Information note

N° 082/22

Change of packing unit volume from 1k devices per reel to 4k devices per reel for products BTS3205N and BSP76 E6327

Change of packing unit volume from 1k devices
per reel to 4k devices per reel for products
BTS3205N and BSP76 E6327

Reel: 1k Packing Unit Volume

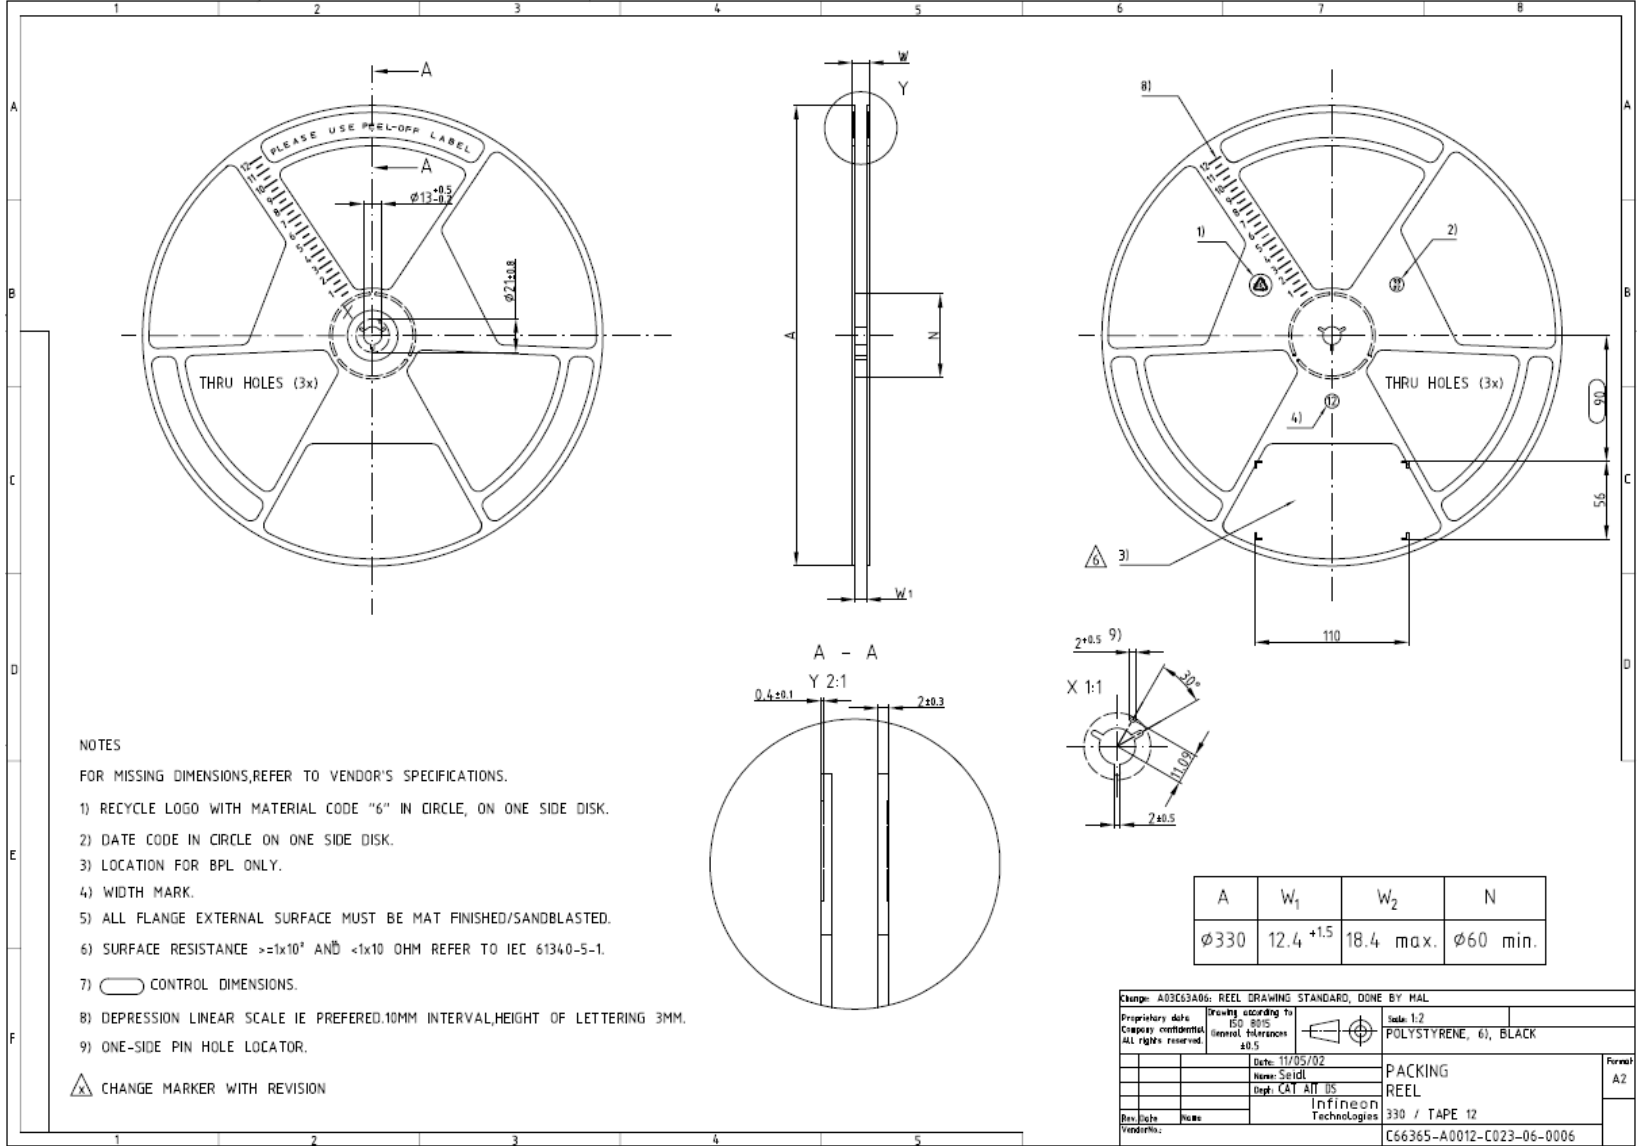
Enlargement of reel diameter from 180 mm to 330 mm.
Enlargement of packing
from 190 x 190 x 24 mm, 200g
to 336 x 335 x 25 mm, 600 g.
Details see 3_cip08222
